DEVELOPMENT APPLICATION ASSESSMENT REPORT

Application Number:	DA2020/0702
----------------------------	-------------

Responsible Officer:	Kent Bull
Land to be developed (Address):	Lot 102 DP 586416, 9 Steinton Street MANLY NSW 2095
Proposed Development:	Alterations and additions to an attached dwelling
Zoning:	Manly LEP2013 - Land zoned R3 Medium Density Residential
Development Permissible:	Yes
Existing Use Rights:	No
Consent Authority:	Northern Beaches Council
Delegation Level:	DDP
Land and Environment Court Action:	No
Owner:	Grant Tyson Brits Ellisa Marjorie Baginska Bennett
Applicant:	Grant Tyson Brits Ellisa Marjorie Baginska Bennett

Figure 1: Section diagram indicating sight/view lines in blue and red.

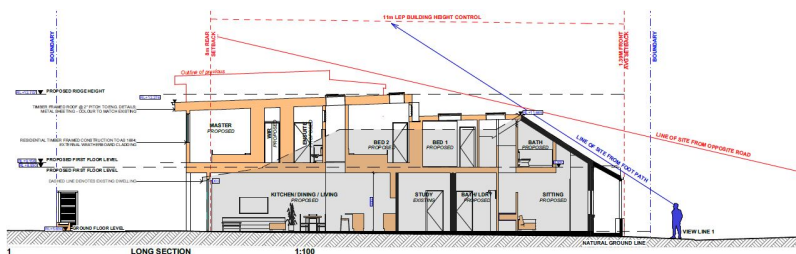
With sight lines (eye height is 1.6m above floor level) provided on submitted plans and the the bulk of the development located to the rear of the site (Figure 1), the proposal is not considered to adversely impact upon the heritage significance of the Federation-era terraces or the associated Pittwater Road Conservation Area. Whilst the existing development at No. 7 Steinton Street is expected to largely obscure the proposed development, a minor portion may be visible from the Whistler Street frontage (Figure 4). As such, the proposed development is considered to be of an appropriate design to ensure it is not visually prominent from the streetscape.

Figure 5. Shadow Diagram at 9am (21 June) depicting the extent of new shadows in blue.

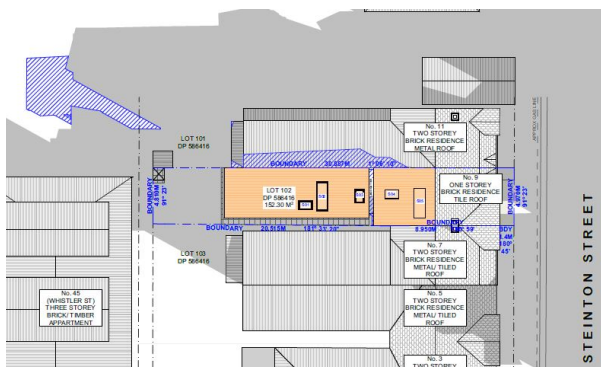
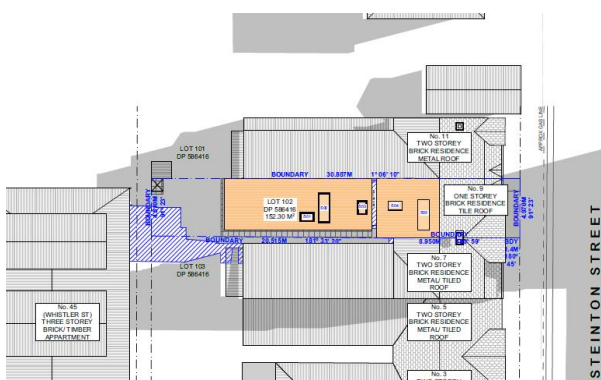
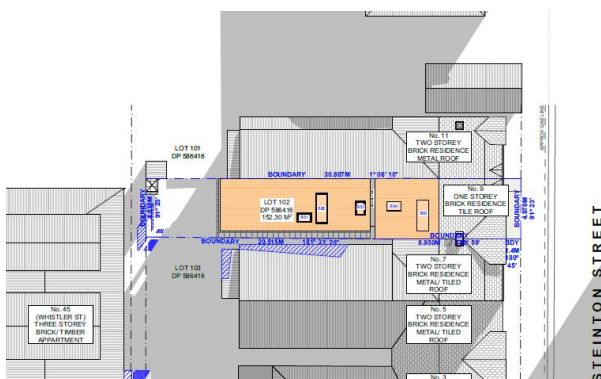
Based on the shadow diagrams submitted (prepared by Action Plans and dated 25 September 2020), all adjoining and adjacent properties with the exception of No. 7 Steinton Street continue to have a compliant level of solar access. It is acknowledged that more than one third (38.5%) of the existing sunlight accessing the private open space areas and the west facing ground floor living rooms windows of No. 7 Steinton Street will be impacted by the proposed development between 9am to 3pm at winter solstice (21 June).

Comment: The shadow diagrams indicate that amount of existing sunlight retained in the rear private open space of No. 7 Steinton Street would be 100% at 9am on June 21. The amount of sunlight lost at 9am is 0m². The amount of sunlight retained in this rear private open space area would be 23% (3.7m²) at 12pm. The amount of sunlight lost at 12pm is 77% (12.5m²). Finally, the amount of sunlight retained in this area at 3pm would be 53% or 1.9m², with the amount of sunlight lost being 47% (1.7m²).
